CONTRACT CHANGE ORDER NO. 203 S2
SHEET 2 OF 8

MARK	DATE	DESCRIPTIONS	BY	CH'D	CCO
3	11/04/11	TOWER ELEVATOR EXTENSION	JNB	FS	203S2
2	08/26/11	ELEVATOR DETAILS	JNB	FS	85
1	07/17/09	ELEVATOR DETAILS	JNB	FS	85

ELEVATOR DETAIL NO. 1

SAN FRANCISCO OAKLAND BAY BRIDGE
EAST SPAN SEISMIC SAFETY PROJECT
SELF-ANCHORED SUSPENSION BRIDGE (SUPERSTRUCTURE & TOWER)

TOWER ELEVATOR EXTENSION DETAILS NO. 2

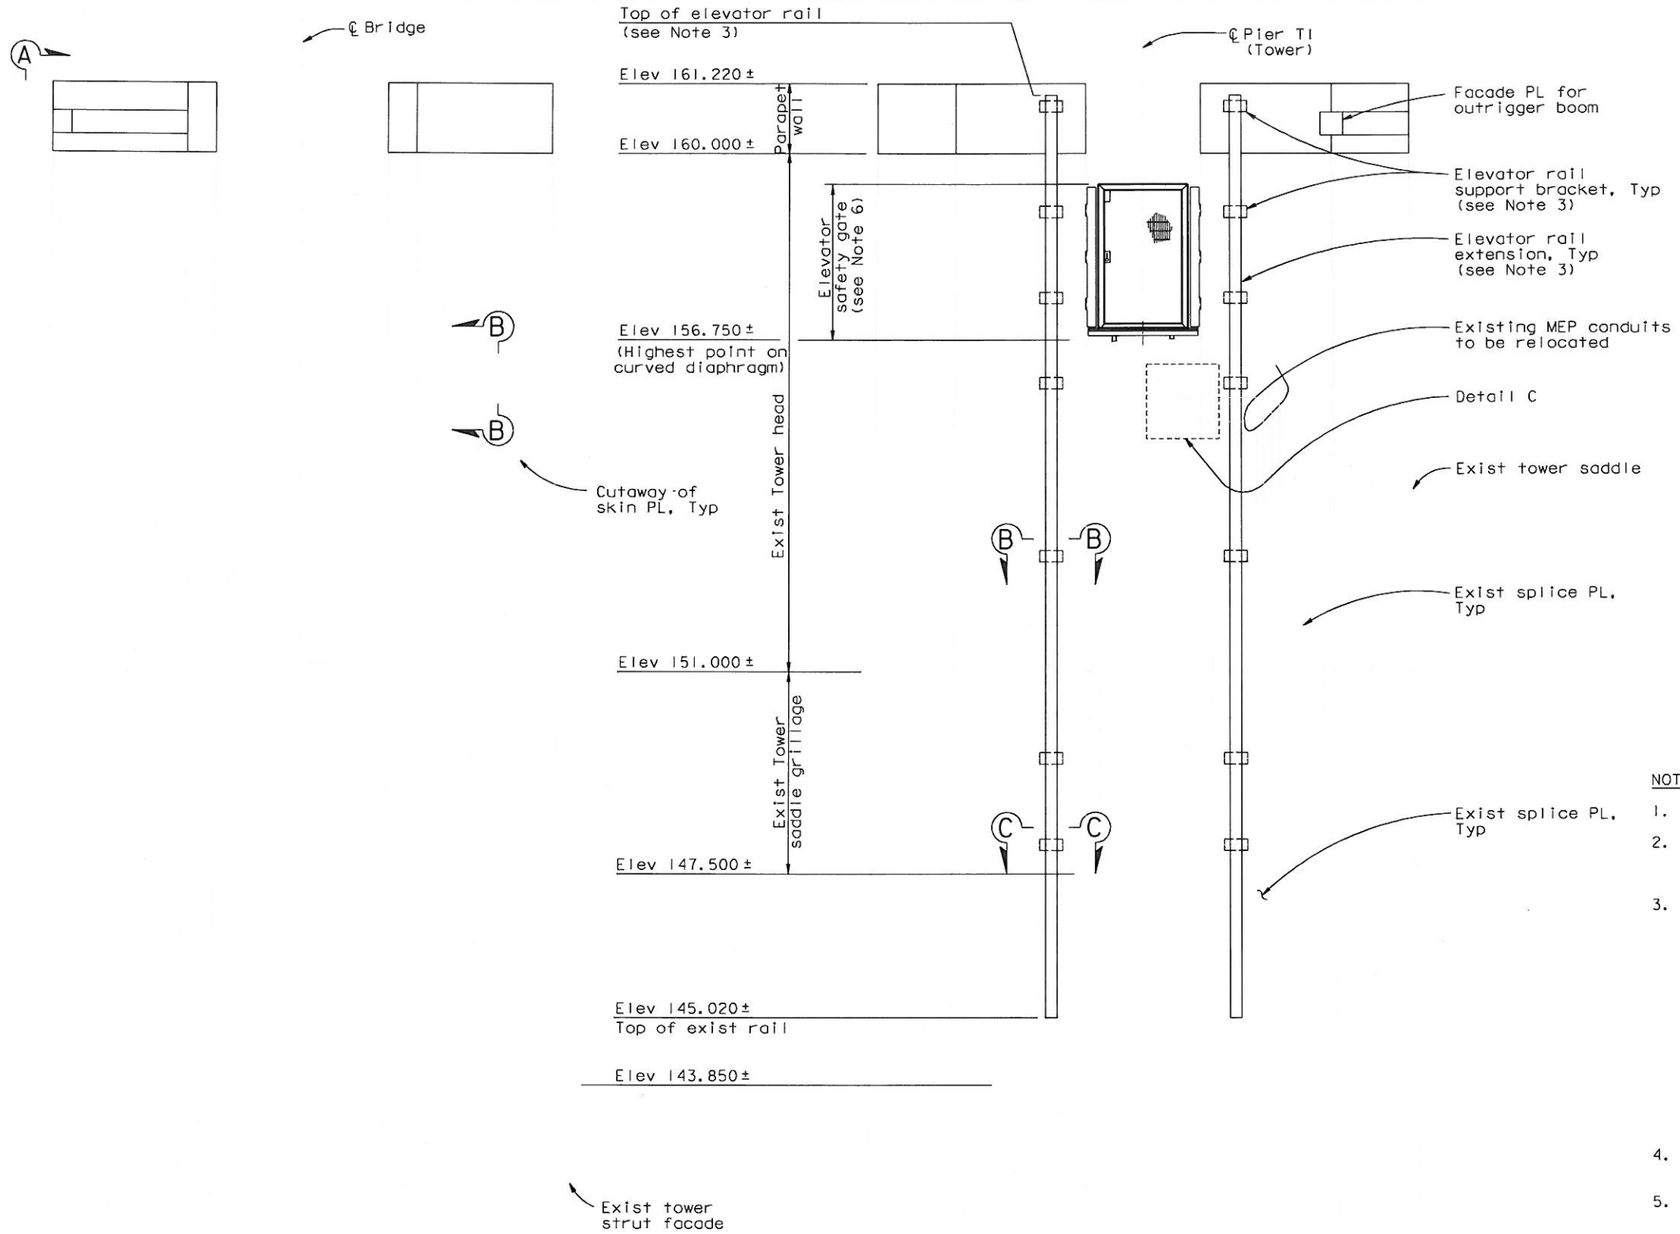
MARK	DATE	DESCRIPTIONS	BY	CH'D	CCO#
1	11/11/11	TOWER ELEVATOR EXTENSION	NV	MN	203S2
0	09/16/11	TOWER SUSPENDER CABLE & ELEVATOR	NV	MN	203S1

3. The following shall be determined by the elevator manufacturer and submitted for review and approval of the Engineer:
   - Details and locations of elevator rail support brackets and connection to supporting structure. Spacing of support brackets shall not exceed 3048 mm.

- Top of elevator rail elevation and stopper details. (Top of elevator rail shall not extend above top of parapet wall. 1
   - Details of elevator rail (mast and rack) and connections to support brackets.
